Deviation NVC-02-DV
HOVWS Alignment – Compound Curve Radii

I-5/SR 16 Interchange/Construct HOV Connections

September 2015

XL 2078 PIN 300566A

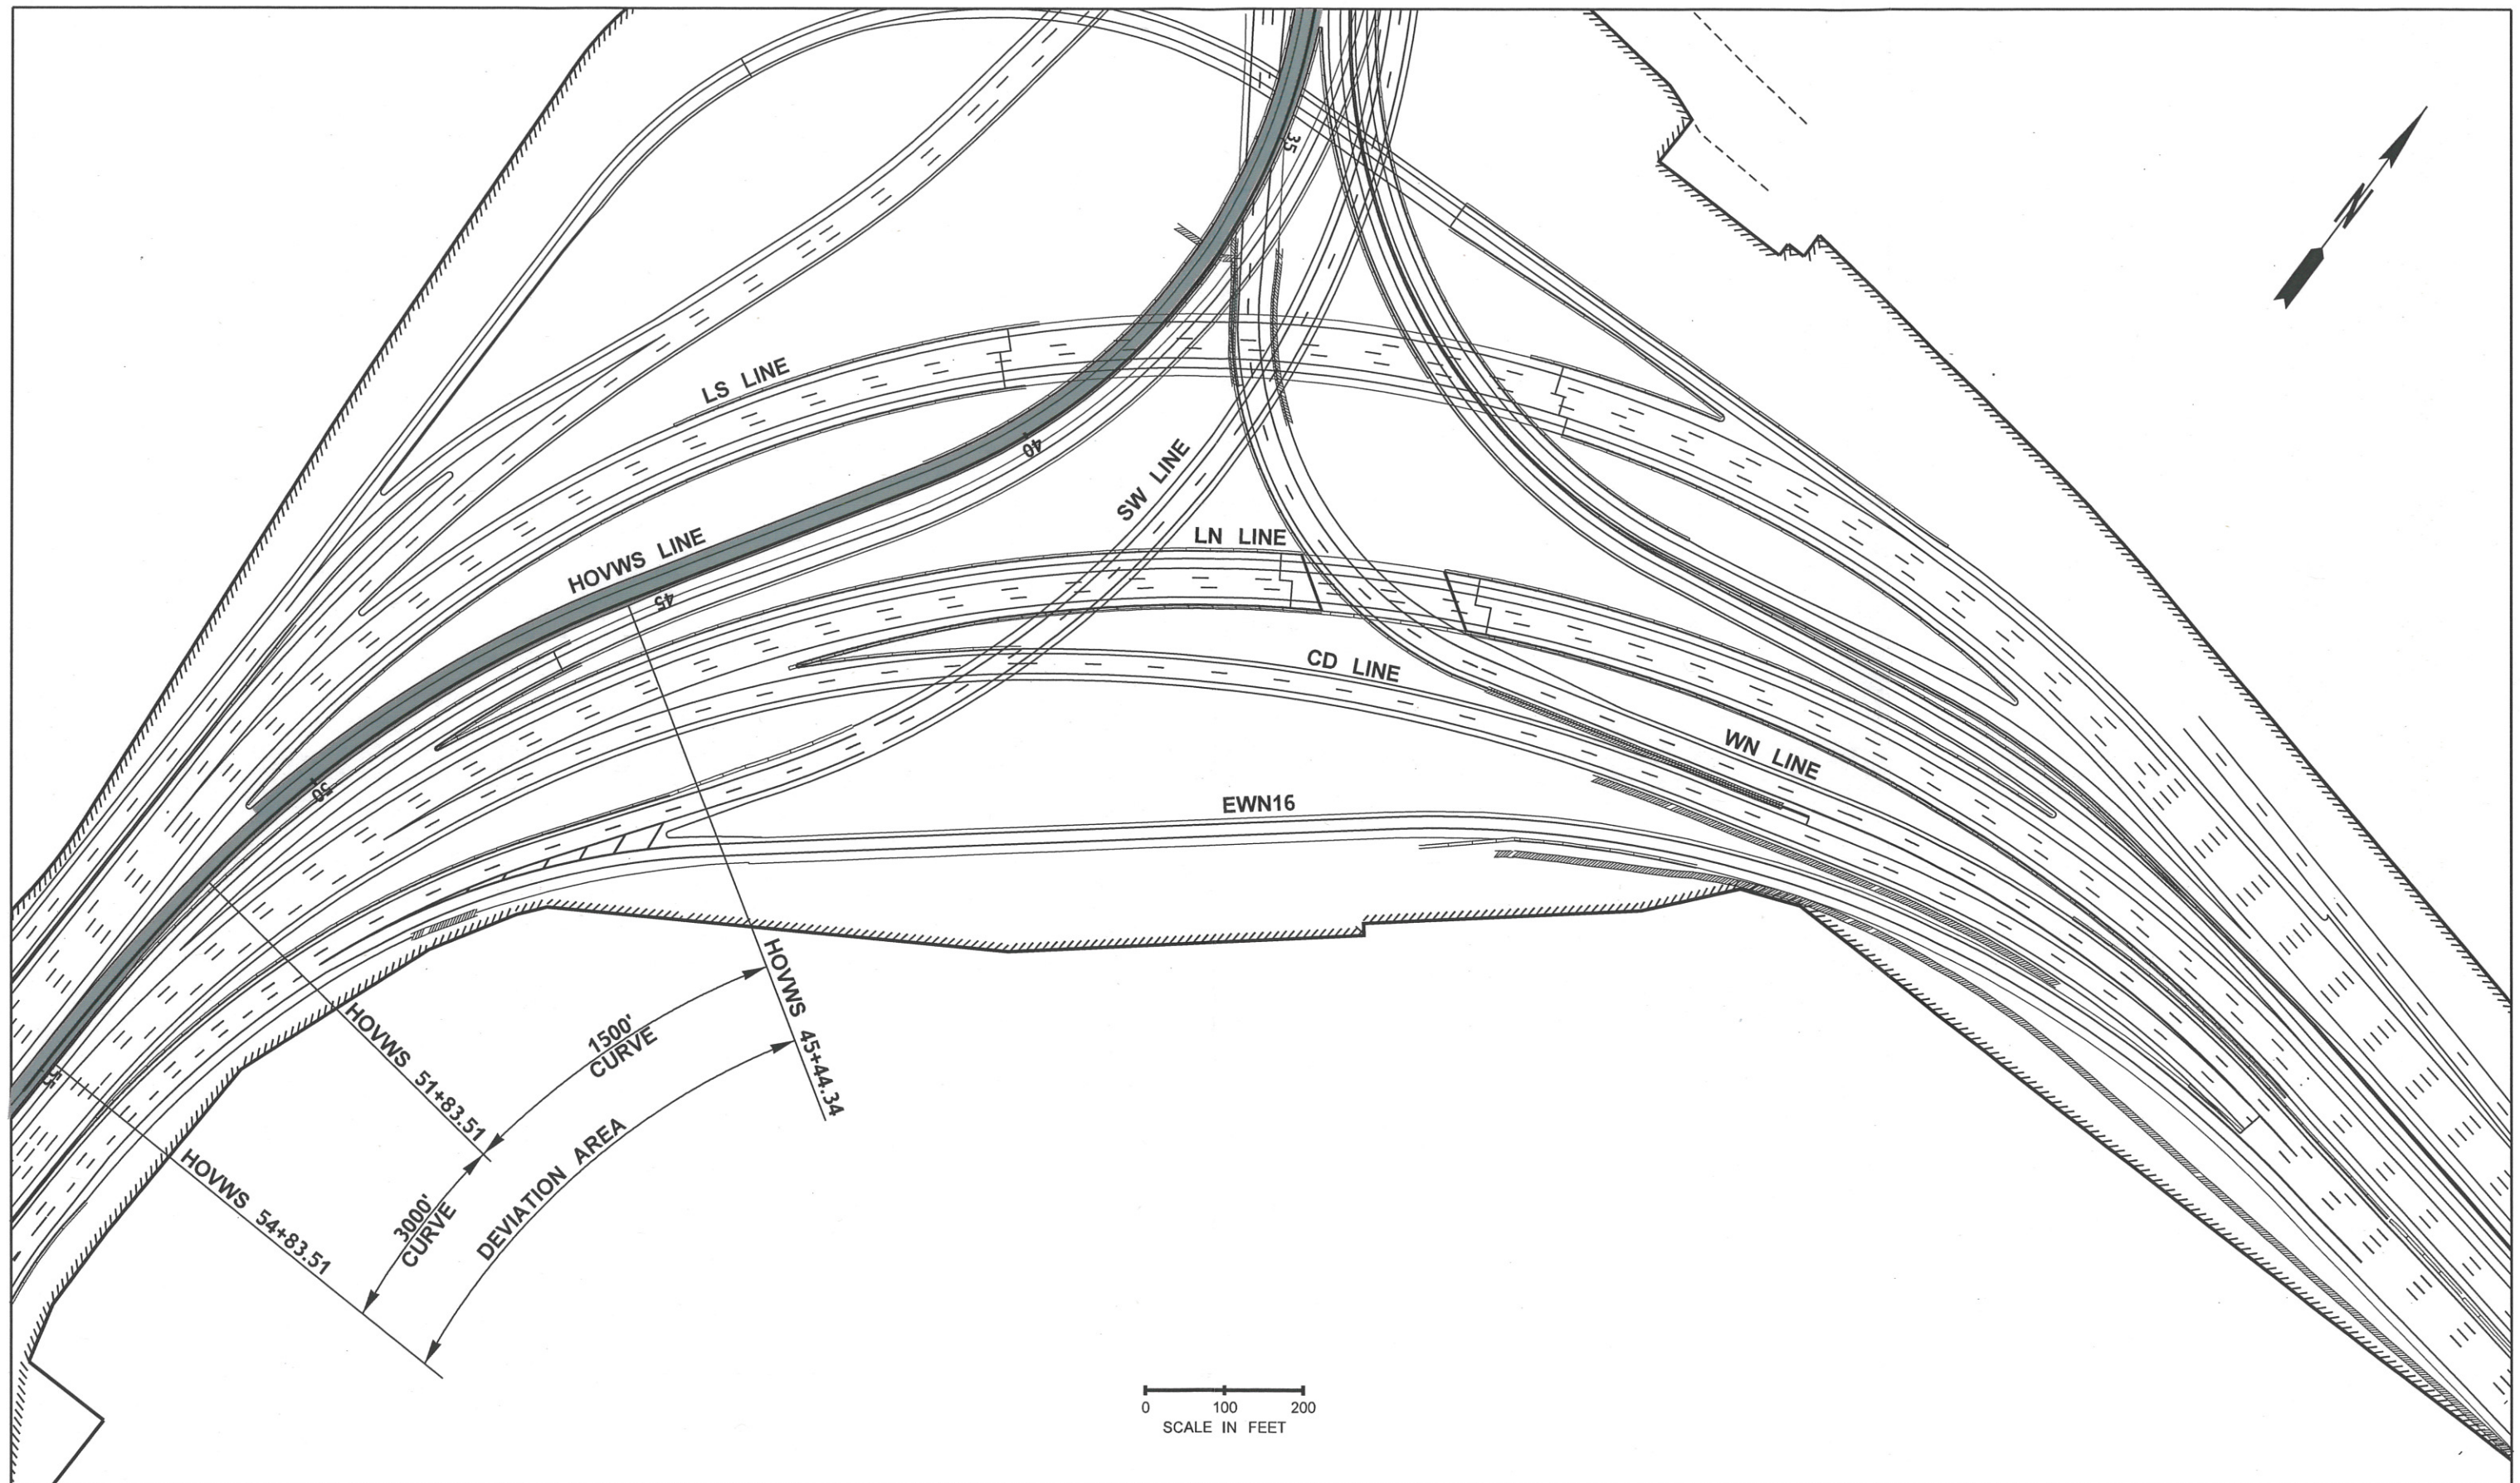
The proposed HOVWS alignment has a compound curve with respective radii of 1500' and 3000'.

DM 1210.04(1)(f) indicates that when compound curves are used, make the shorter radius at least two-thirds the value of the longer radius. Chapter 3, page 3-112, of *A Policy on Geometric Design of Highways and Streets* (2011 AASHTO Green Book, 6th Ed) has the same criteria, plus the additional guidance that on one-way roads, such as ramps, the difference in radii of compound curves is not as critical if the second curve is flatter than the first.

Revise either of the curve radii so that the two-thirds design standard in the WSDOT Design Manual is met. This could be done by shortening the radius of the second curve so it does not exceed 2250', or increasing the radius of the first curve to at least 2000'.

- The HOVWS ramp is immediately adjacent to the HOVSW ramp, which is the direct HOV ramp from northbound I-5 to westbound SR 16. The ends of the HOVWS alignment, at the limits of the compound curve, can't be shifted due to connecting to the HOV16 ramp to the north and merging with mainline I-5 (LS Line) to the south. Increasing the radius of the first compound curve is not possible, as it would result in a conflict between the two HOV ramps.
- The HOVWS/LS merge is a parallel-on design (DM 1420.05(6)(a) (July 2013)). Decreasing the second compound curve radius would increase the superelevation on the ramp LS, where the parallel gap acceptance portion of the on-ramp begins, and is in a crown section (2% slope). If the second ramp was decreased, the ramp would have a superelevation of 6% to 7%.

- It is compatible with the adjacent alignments (LS and HOVSW).
- It meets the Note 3 of DM Ex. 1360-13b (June 2009), which indicates a transition curve of 3000' is desirable prior to the parallel portion of the ramp.
- AASHTO criteria is met; the second curve is flatter than the first.

The recommendation of the Olympic Region is to deviate compound curve design on the HOVWS Line from the WSDOT Design Manual standard and conform to the AASHTO standard. The design will provide a compound curve where the second curve has a radius twice the length of the first curve. The Olympic Region bases the recommendation on limited room in which to vary the design, based on the urban nature of the interchange and the recently constructed adjacent facilities, and engineering judgment. The Olympic Region proposes to build this section of the HOVWS alignment as currently designed with compound curve radii of 1500' and 3000'.
